In response to Mr. Wiley's August 21 letter, Zenith and AT&T hereby submit to the Technical Subgroup of the Special Panel a description of improvements in the DSC-HDTV system that we would like to have considered by the Special Panel and the Advisory Committee. Our description includes improvements already implemented which could be tested now, improvements currently under way which could be included in field testing early next year, and additional improvements that could be made in the future. We also describe our method for incorporating the ATSC T3/186 audio and ancillary data features into our system, as Mr. Wiley's letter requests.

DSC-HDTV
System Improvements

**Zenith
Electronics
Corporation**

October 26, 1992

Figure 2. Typical Quantizer Selection Pattern

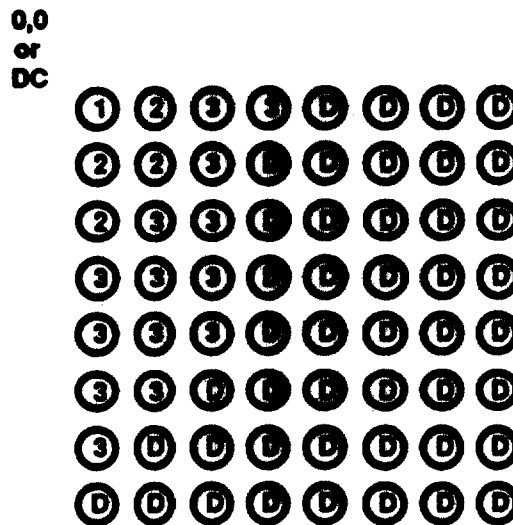
The old codebook did not contain enough vectors to allow quick correction of small quantization errors. This resulted in:

- Relatively slow correction of accumulated quantization errors, giving a "twinkle" effect in still pictures.
- Visible block artifacts in:
 - high detail still pictures
 - pictures with high levels of source noise
 - high frequency zone plates
- Overall reduction in coding efficiency

The improved code book has additional vectors which select small subsets of DCT coefficients for quantization. A typical new selection vector is shown in Figure 3. The implementation of this change was an update to a table in the encoder and decoder. The effect of this improvement was to reduce greatly any slowly varying changes to the quantization error and to provide an overall increase in picture quality due to a reduction in the number of bits wasted to send coefficients that were quantized to zero.

- Removal of "twinkle" in stills
- Removal of many block artifacts from high frequency zone plates
- Greatly improved coding of pictures with source noise
- Overall increase in coding efficiency

Figure 4. Encoder And Decoder Loops

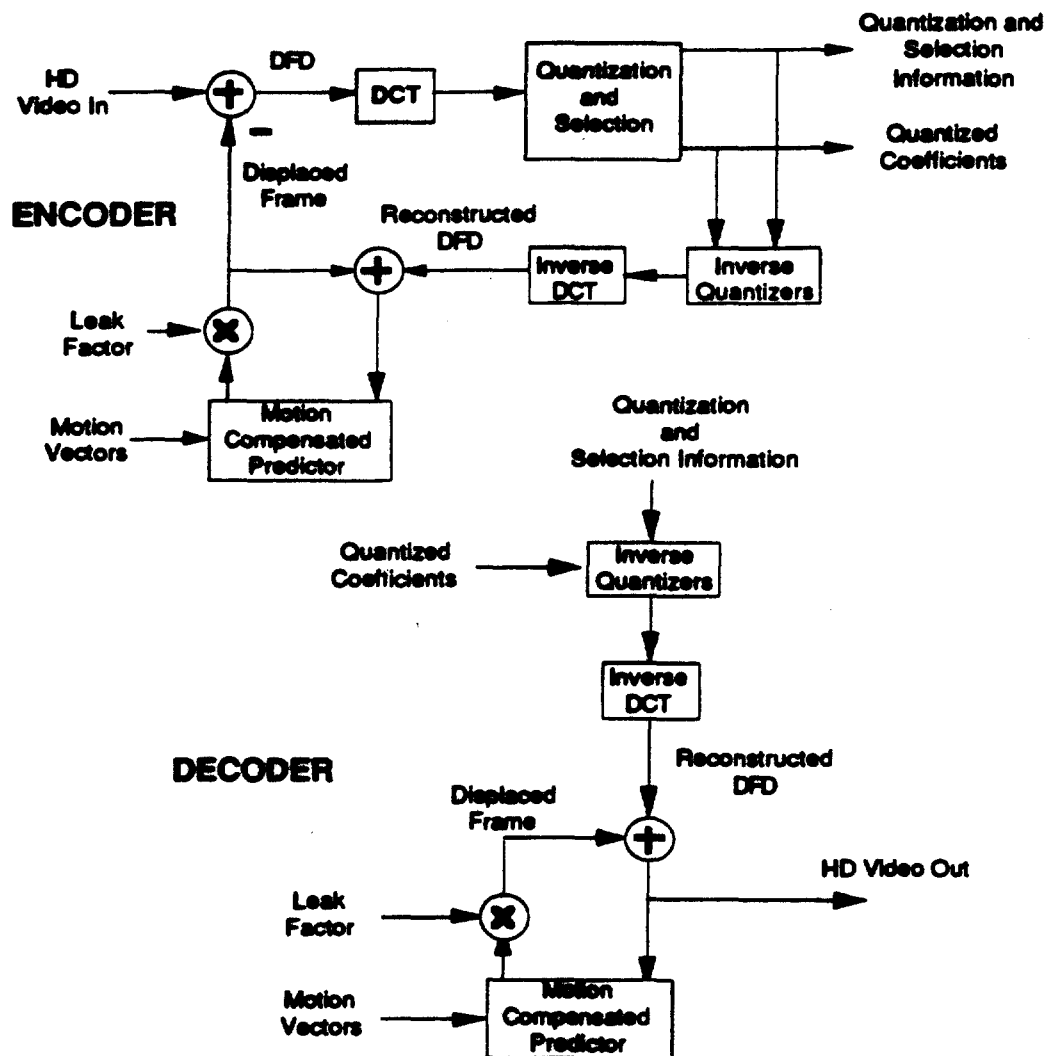
Due to lack of pre-test tuning time, a suboptimal fix was implemented which added a cyclic offset to the frame mean value used in the encoder.

- Mean offset caused a periodic increase in the average value of the displaced frame difference (DFD) which resulted in temporal variation in the DC coefficient energy.
- Overall coding efficiency was decreased.
- Slowly varying and periodic changes ("breathing") to DC coefficient quantization error were visible in very complex scenes such as moving zone plates and rotating radial resolution charts.
- Maximum leak was limited to 15/16, forcing use of unity leak (perfect prediction) for six of seven frames. Thus, leak was applied once in seven frames.
- Periodic leak cycle caused oscillations in the buffer control system.
- Uncorrected transmission errors did not decay rapidly, due to application of the leak factor only once in seven frames.

The improved system does not offset the mean but applies a variable offset in the leak calculation. The leaked value is calculated by shifting the original value (dividing by powers of two) and then subtracting this from the original value. The offset is applied to the shifted value. The sequence of offset values is common to both encoder and decoder, which are synchronized by a bit in the global data. Thus, leak calculation error is reduced without adding to the DC coefficient amplitude.

- Removal of "breathing" in high frequency zone plate
- At the same level of picture distortion, the amount of 2-level data is increased by about 50%, or
- At the same amount of 2-level data, the picture distortion is decreased by about 50%

Figure 5. Basic Picture Quality Improvement

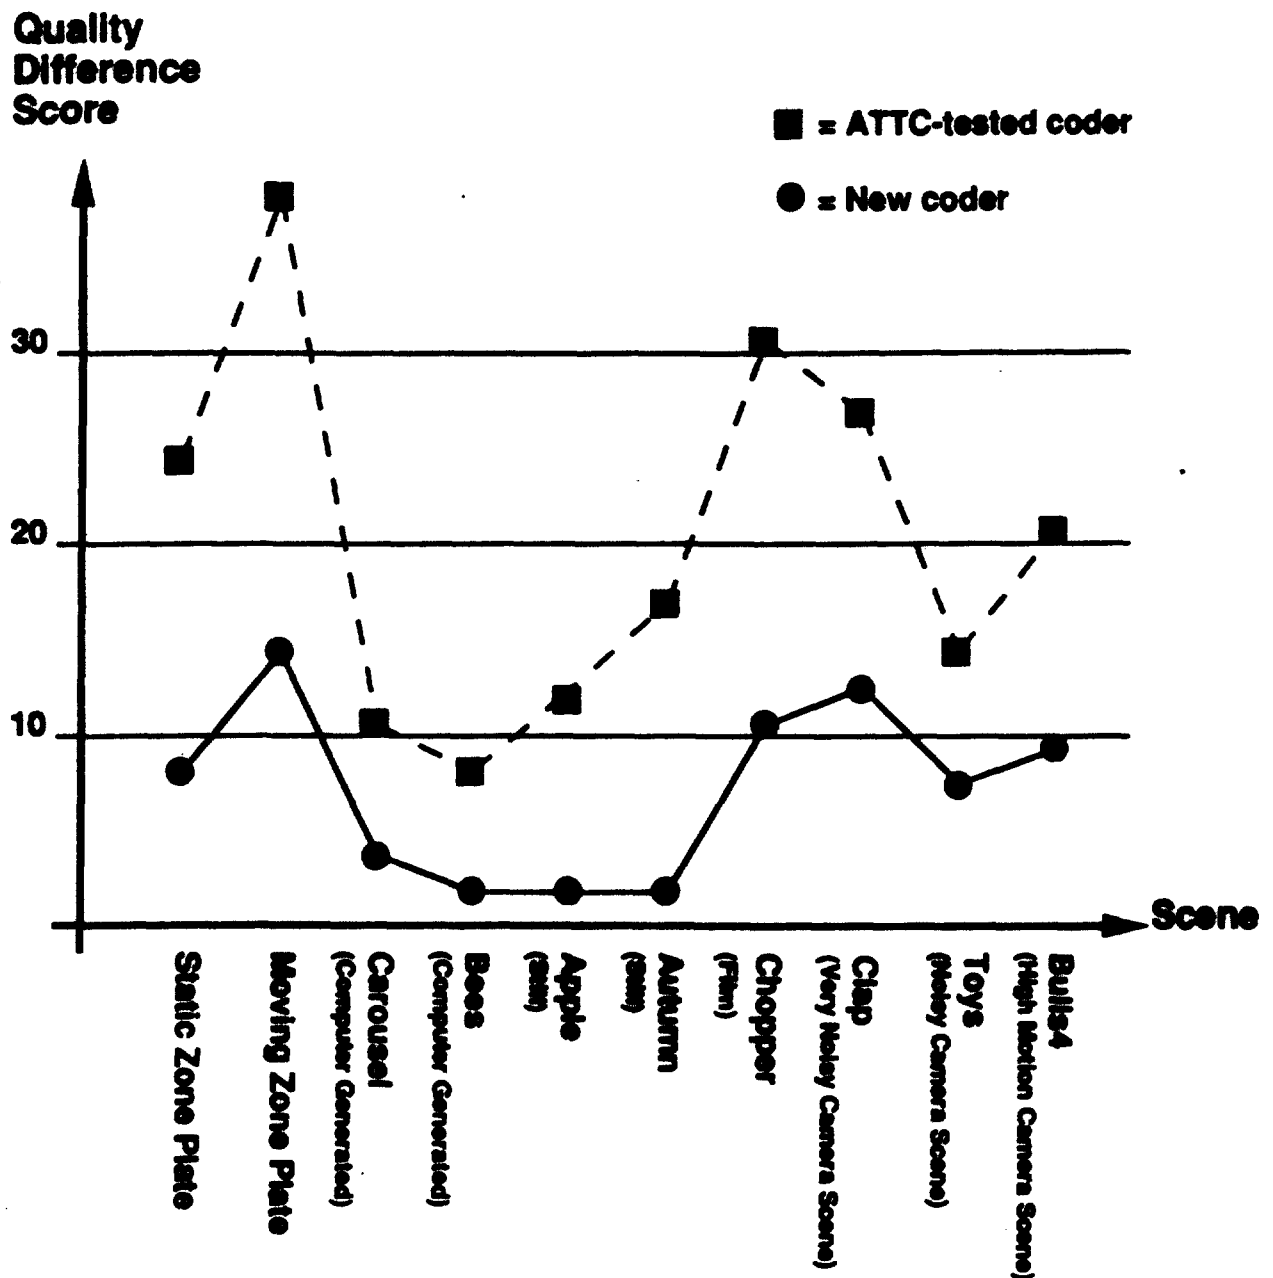
Based on the above improvements, a series of tests was run to quantify the overall improvement in the system. Table 2 and Figure 5 present the results of these measurements. As indicated in Section 2, we are currently optimizing the trade-off between picture quality and transmission performance for optimum soft-coding. After such a trade-off is completed, the precise improvement numbers may be slightly different. However, for the indicated number of binary segments, the following improvement numbers are accurate.

Note: This graph was made by "informal" subjective tests. Three expert observers were used. Coded pictures from the ATTC-tested coder and the new coder were separately compared to the reference (uncoded 787 picture) and differences in quality scores were plotted. The scores are on a scale of 0 to 100, similar to one used by ATEL. A difference of 20 in score corresponds approximately to one point on a five-point comment scale.
